**From:**  
**Sent:** 15 February 2025 21:12  
**To:** DC Admin  
**Subject:** 2023-91280 Bromley Farm Quarry transport Vehicle & Wheel Washing

2023-91280 Bromley Farm Quarry transport Vehicle & Wheel Washing

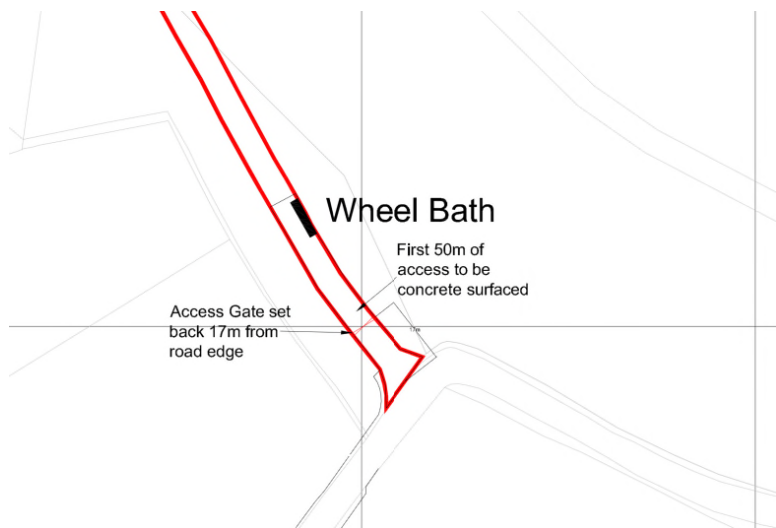
There is no details of the wheel washing

Objection : **a bath does not clean adequately for the highway**

A planning condition should be a full drive-through automatic washing for side/underbody, chassis Tyre and wheels system

The size of the auto-wash system should be specified to include all vehicles; including cars, leaving site

There is no Bund facility shown

There is no indication of additional water IBC's/tanks to supply the clean water

There is no system showing storage tanks how they clean / recover debris cleaned & any water used

There are no site lights shown so that drivers may inspect the vehicles are clean before entering the highway

There are no additional cross-drainage channels indicated on the sloping access road, so that water coming from the vehicles is channelled away into a soakaway and NOT directly onto the highway
